**FINDINGS AND RECOMMENDATION
OFFICE OF PLANNING AND ZONING
ANNE ARUNDEL COUNTY, MARYLAND**

CASE NUMBER: 2025-0125-V

REQUEST

The applicant is requesting a variance to allow a tenant identification sign supported by poles, uprights, or braces extending from or attached to the roof of a structure located at 530 Ritchie Highway in Severna Park.

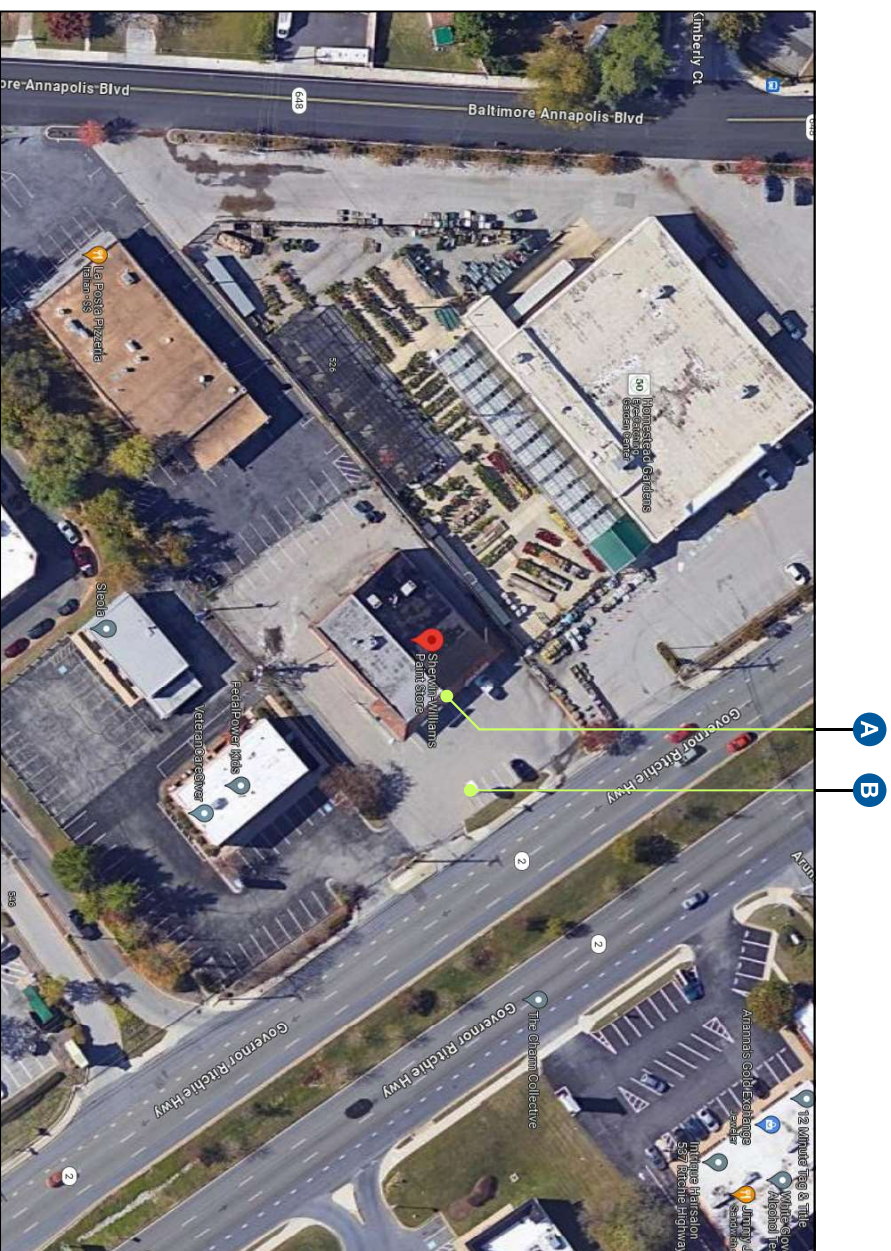
In this particular case, the existing one-story structure's facade is only 11'-4" high, at which point there is a deep roof overhang. Further complicating the matter, the majority of the front facade of the building is made up of glass windows, preventing the mounting of a facade sign. There is only a small brick section on the left side of the front facade that could potentially allow for the mounting of a facade sign, but that area is less than 15 feet wide.

County oblique aerial images show that there have been two roof-mounted signs, one for each of two tenant spaces, at this location since at least 2006. The applicant intends to remove the two existing roof-mounted signs from each side and to construct one roof-mounted sign in the center, as there will only be one tenant for the entire building. The proposed sign would be attached similarly to those that have existed for an extended period of time.

The proposed identification sign would not alter the essential character of the neighborhood, substantially impair the appropriate use or development of adjacent properties, or be detrimental to the public welfare. With limited facade signage options due to the style of the building construction, the deep roof overhang, and the glass front, the requested variance is justified and is considered to be the minimum necessary to afford relief.

Based upon the standards set forth in § 18-16-305 of the Code under which a variance may be granted, this Office recommends ***approval*** of the proposed variance to § 18-3-303(b)(4) to allow a tenant identification sign supported by poles, uprights, or braces extending from or attached to the roof of a structure, as shown on the sign plan submitted by the applicant.
